**DRAWING AMENDMENTS**

Appl. No. 10/021,531  
Amdt. For Reply to Office Action Dated August 13, 2003  
REPLACEMENT SHEET

**Figure 2**

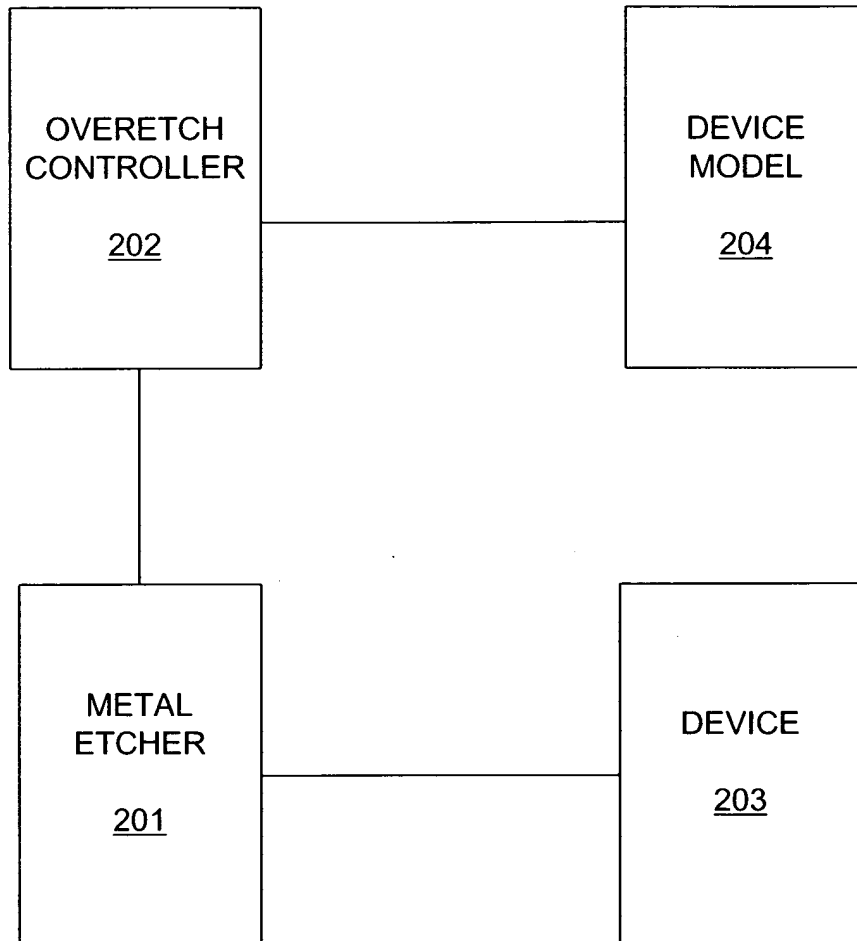
The attached drawing sheet includes a change to Figure 2. This sheet replaces the original sheet including Figure 2. Figure 2 is being amended to make it consistent with the specification. In particular, block 202 labeled "OVERETCH SYSTEM" has been changed to read "OVERETCH CONTROLLER."
